## Product Change Notice (PCN)

**PCN Number: PCN-0451100R-01**

Product(s) Affected: SJD1-3201-54

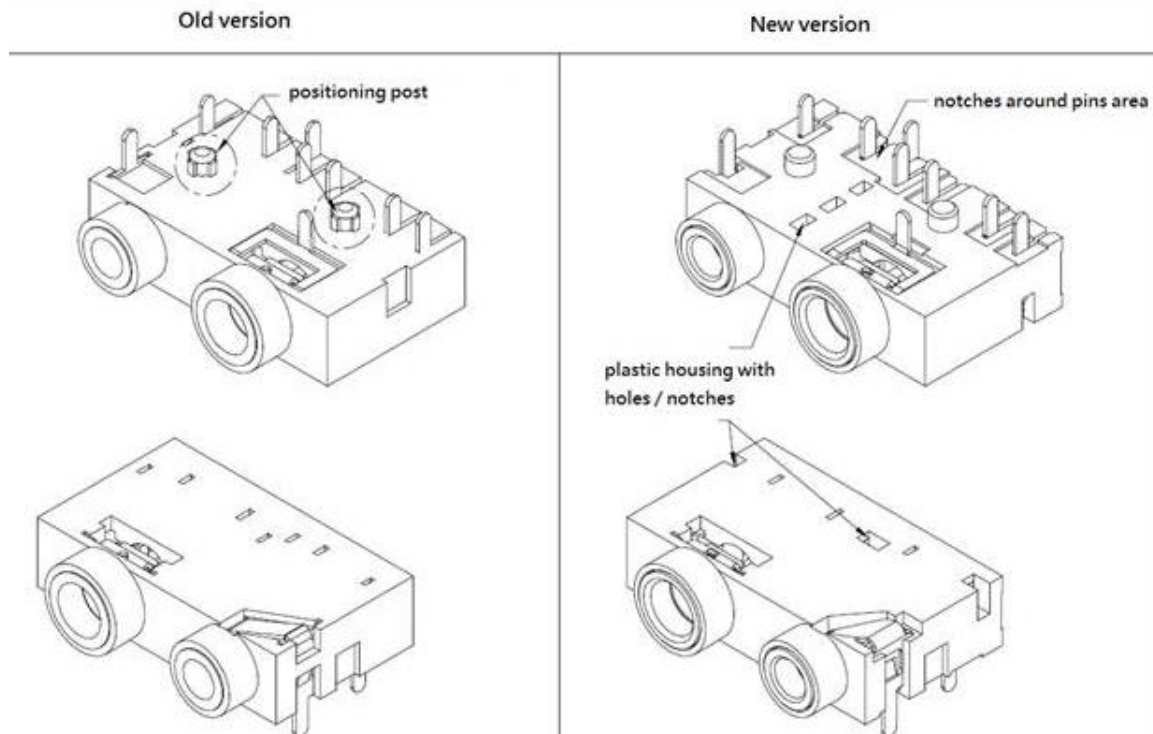
Description of Change: new tooling mold causes slight different appearance:
